DART SERVICE INSTRUCTION

TO AMEND INSTALLATION INSTRUCTIONS II145-6 Rev. A or later,

2.1 RELAY INSTALLATION INSTRUCTIONS

FIGURE 2: RH CABLE CHANNEL RELAY INSTALLATION LOCATION

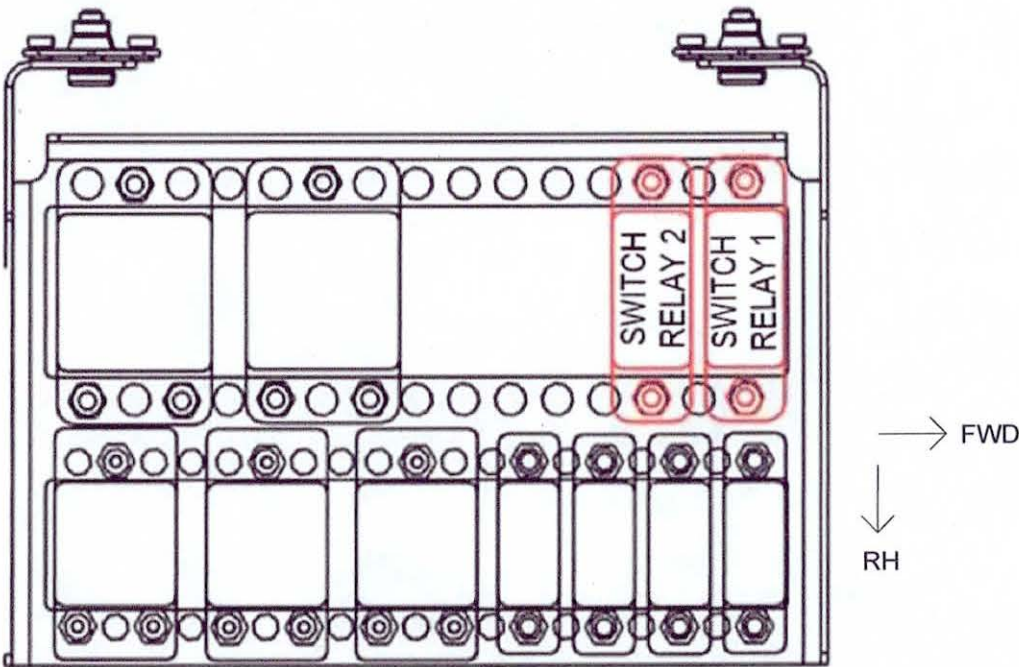
1. Install two relay sockets (P/N 601.1682) into the relay holder in the cable channel on the FWD RH side of the aircraft as shown in Figure 1 and Figure 2 of this DSI.

1. Install one relay socket (P/N 601.1682) into the relay holder in the cable channel on the FWD RH side of the aircraft as shown in Figure 1 and Figure 2 of this DSI.
2. Install one relay (P/N 601.1627) into the relay socket.
3. Route wire 4102-M20 from the Instrument Panel to the relay at pin A2.
4. Splice wire 4101-M20 to SPDA9 and route to the relay pin X1.
5. Route wire 4103-M20 from splice SPDA1 to the relay pin X2.
6. Splice wire 4125-M20 to SPDA6 and route to relay pin A1.
7. From splice SPDA6, route wire 4107-M20 to connector pin A and wire 4124-M20 to connector pin C.
8. Wire 4104-M20 that is spliced to SPDA2 will now be routed to SPDA8 and from there to ground.

1. Install one or two relay sockets (P/N 601.1682) into the relay holder in the cable channel on the FWD RH side of the aircraft as shown in Figure 1 and Figure 2 of this DSI.
